RE: Response Letter 2 – TAC Comments 375 Banfield Road, Portsmouth, NH Tax Map 266, Lot 7 JBE Project No. 19190.2

Subject: Proposed Industrial Warehouse Building - Response to Comments

COMMERCIAL SITE PLAN "INDUSTRIAL WAREHOUSE" TAX MAP 266, LOT 7 375 BANFIELD ROAD, PORTSMOUTH, NH

Plan Name:	HIGHWAY ACCESS PLAN
Project:	INDUSTRIAL WAREHOUSE 375 BANFIELD ROAD, PORTSMOUTH, NH 03801
Owner of Record:	BANFIELD REALTY LLC 304 MAPLEWOOD AVENUE, PORTSMOUTH, NH 03801

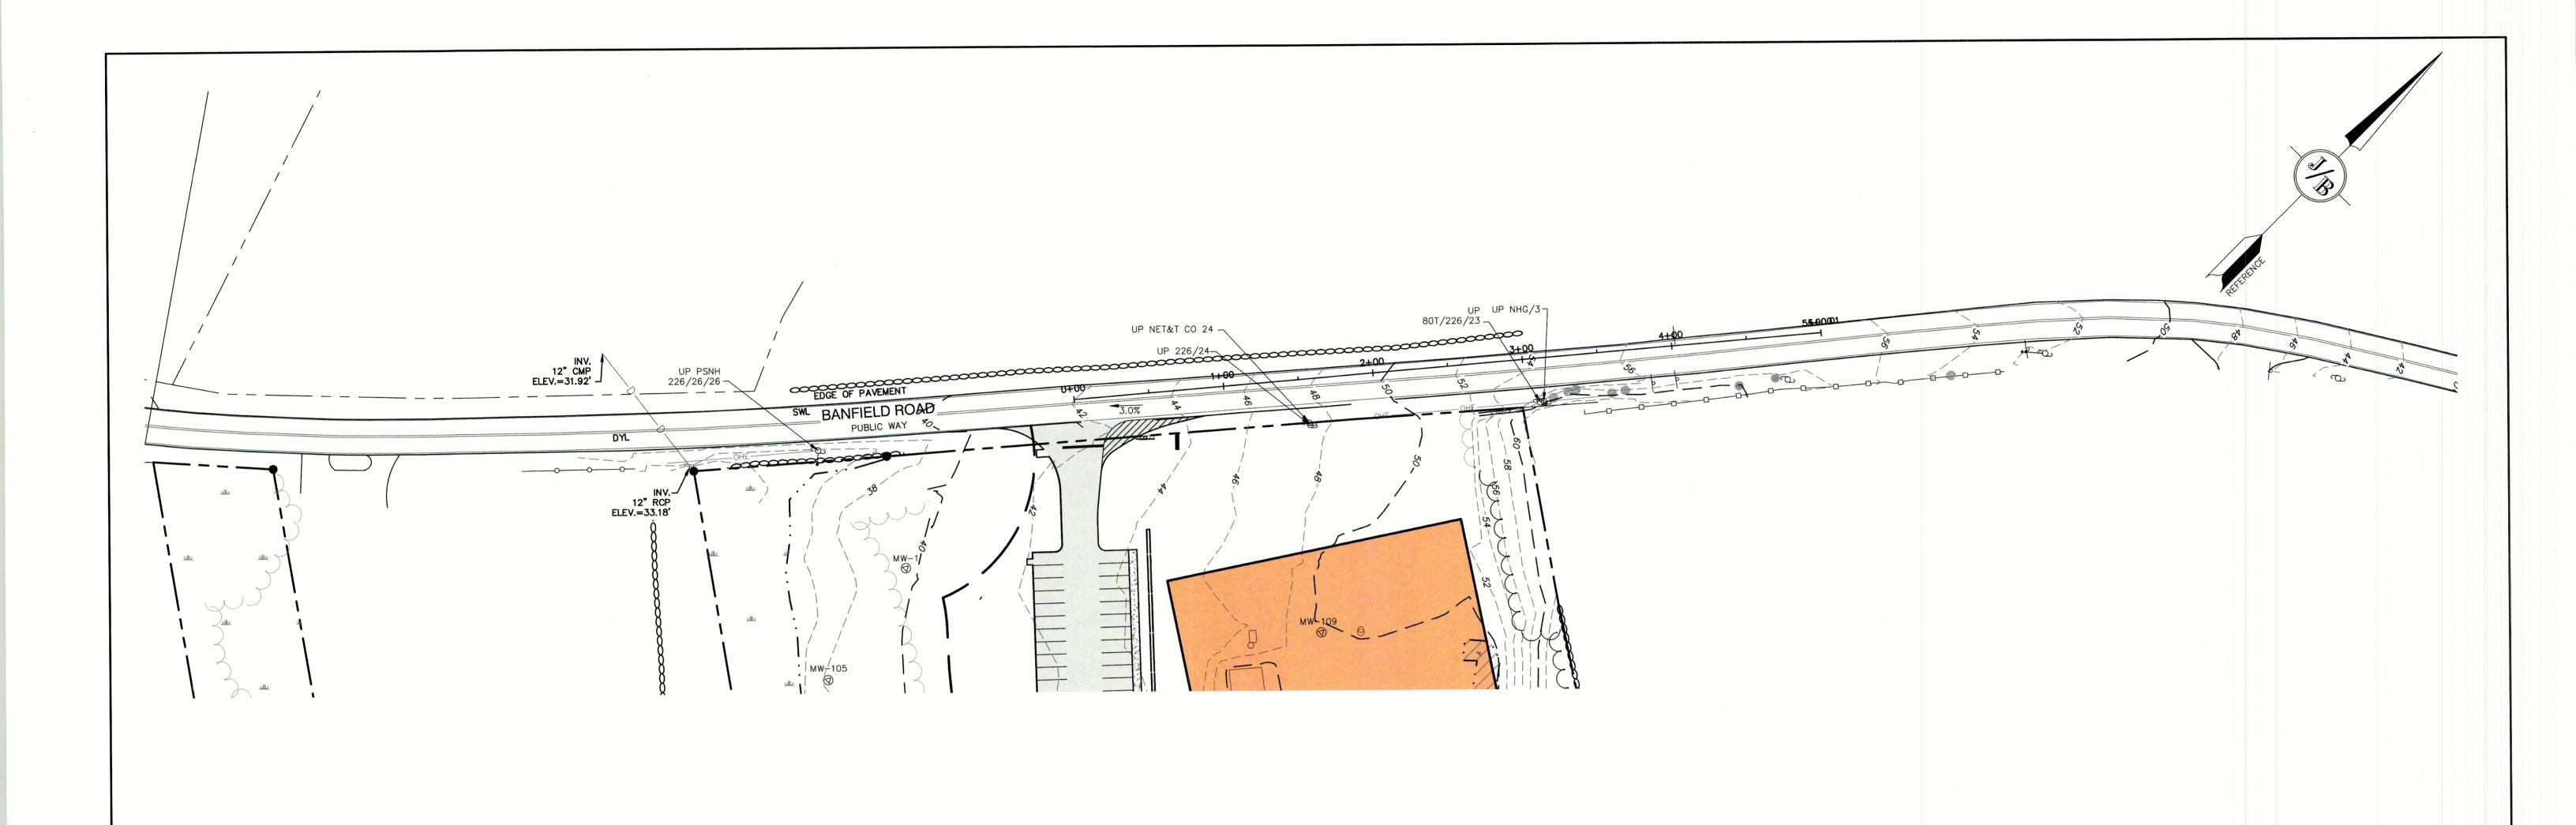
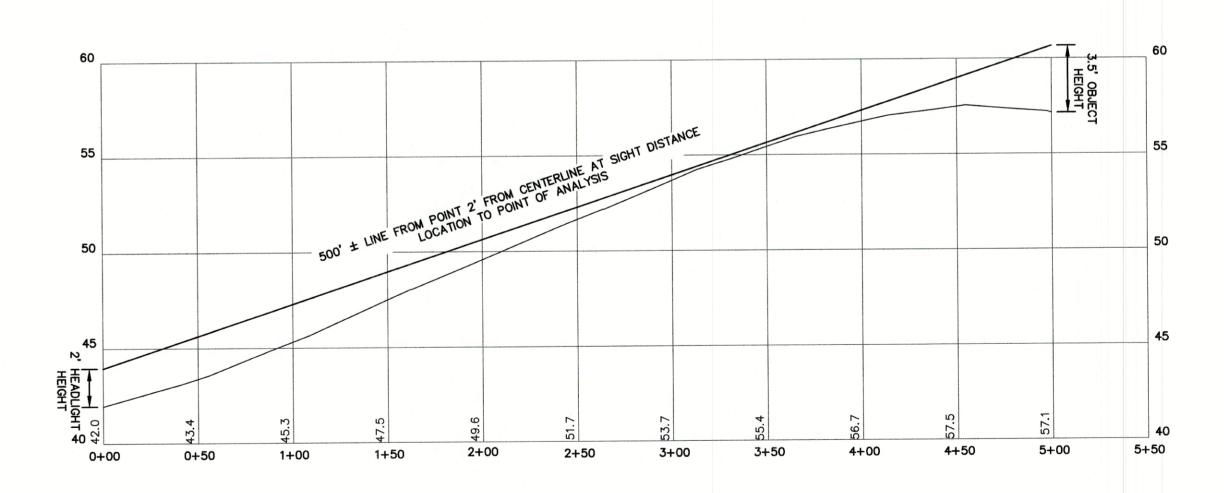
TAC Comment 2: "The stopping sight distance is met at the proposed driveway location, which means that a vehicle traveling on Banfield Road will have enough time and distance to be able to come to a complete stop without colliding with a truck exiting the site. However, this is not a desirable condition, having to require vehicles to come to a complete stop to allow for entering trucks. It would be preferable if the intersection sight distance could also be provided, which is over 675 feet. Intersection sight distance provides enough time and distance for approaching vehicles to slow to 70 percent of their travel speed when a truck is exiting the driveway."

SGP Response: Sheet H1 indicates that there is over 500+ feet of Intersection Sight Distance (ISD) available for the left-turn departure movement from the proposed site driveway. This exceeds the calculated distance required of 441.0-feet for passenger cars. This sheet also indicates that there is at least 347-feet of ISD for the right-turn departure movement (limited by extent of field survey), and that additional sight distance is available beyond the survey limit. This compares well with the calculated distance of 382.2-feet for passenger cars.

Plan Name:	OVERVIEW TRUCK TURNING PLAN
Project:	INDUSTRIAL WAREHOUSE 375 BANFIELD ROAD, PORTSMOUTH, NH 03801
Owner of Record:	BANFIELD REALTY LLC 304 MAPLEWOOD AVENUE, PORTSMOUTH, NH 03801

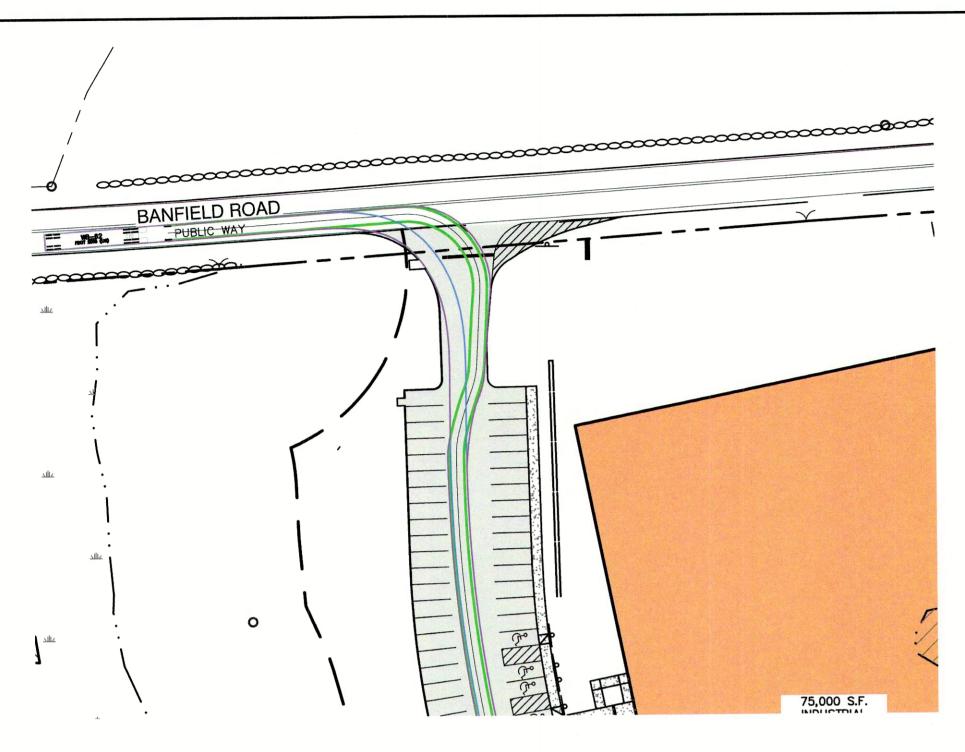
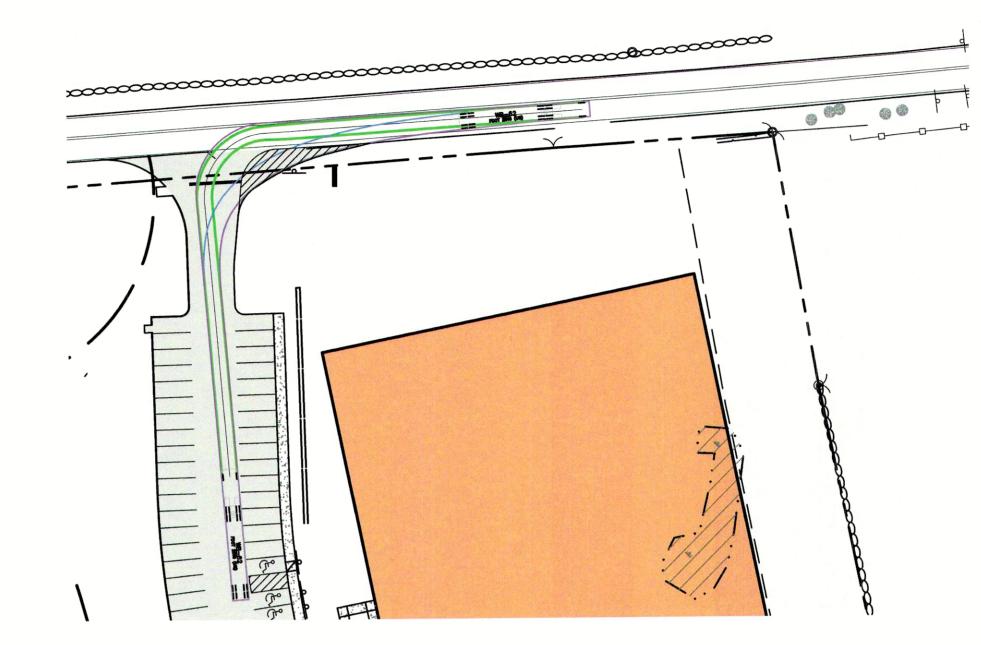
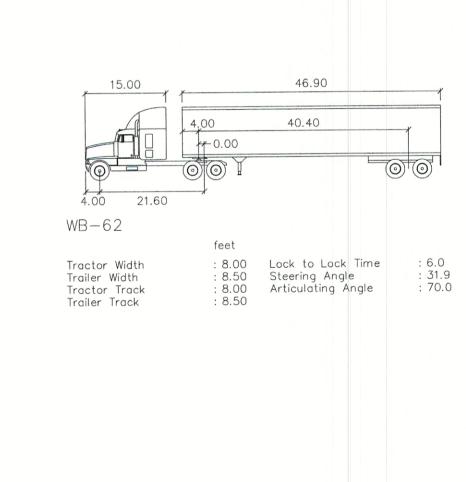
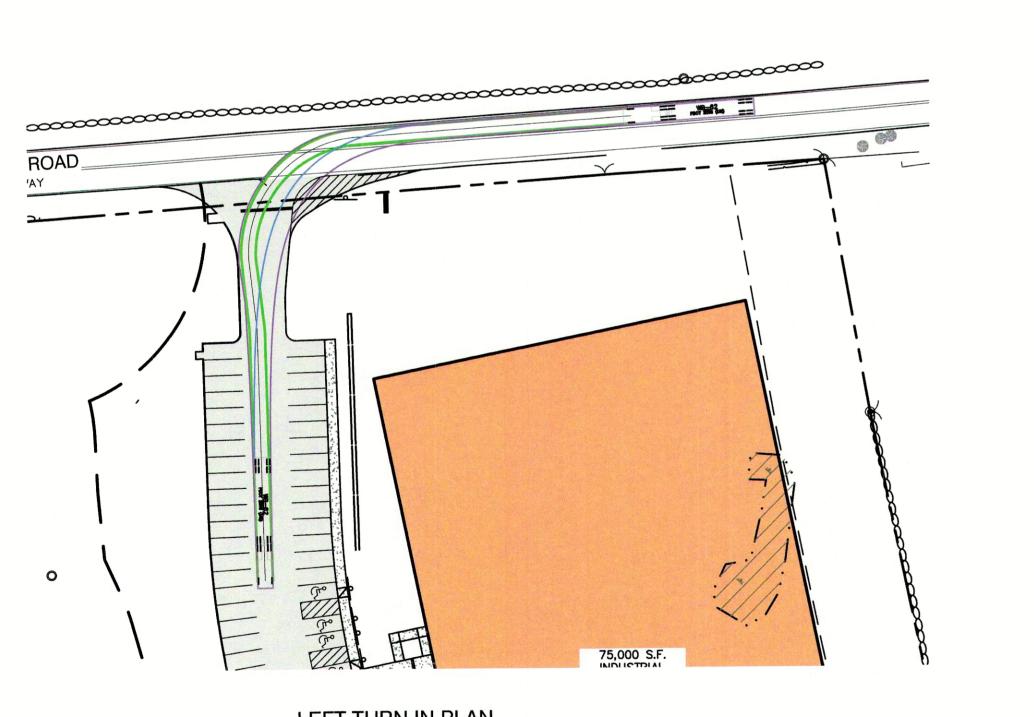
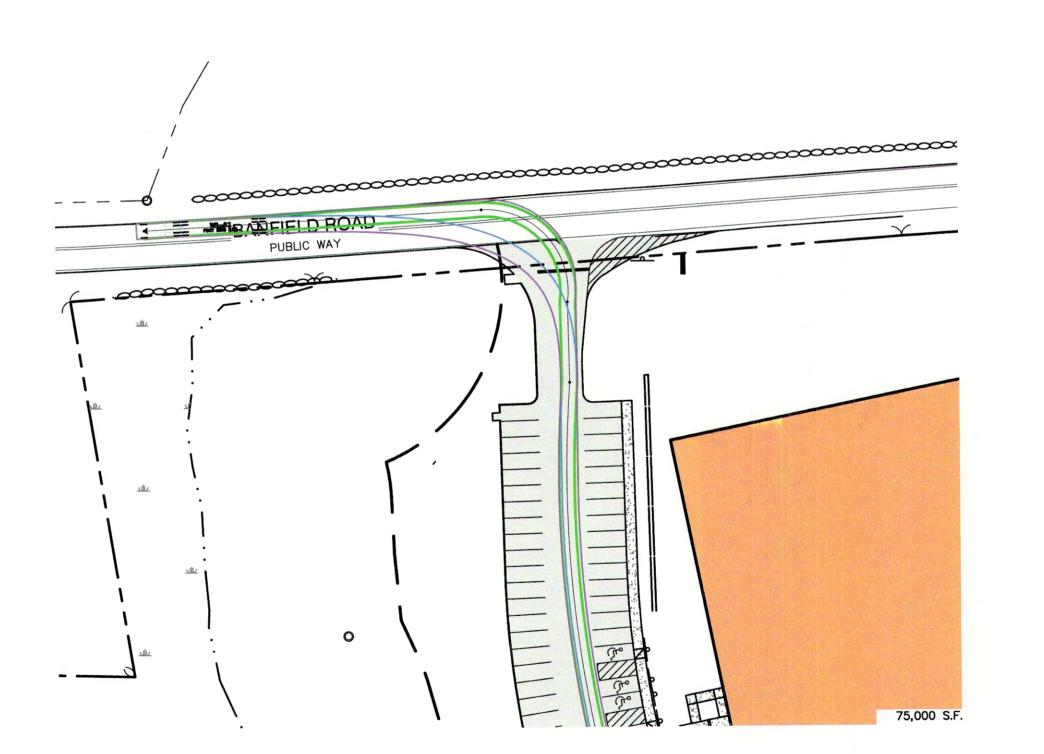
5. According to the turning paths shown on sheet T1, large trucks turning right from the site driveway will not be able to start their turn at the position indicated on Sheet T2. The right turn path should be replotted to show the truck following the same path as on Sheet T1.

RESPONSE: The right turn path has been replotted to show the truck following the same path as on Sheet T1.
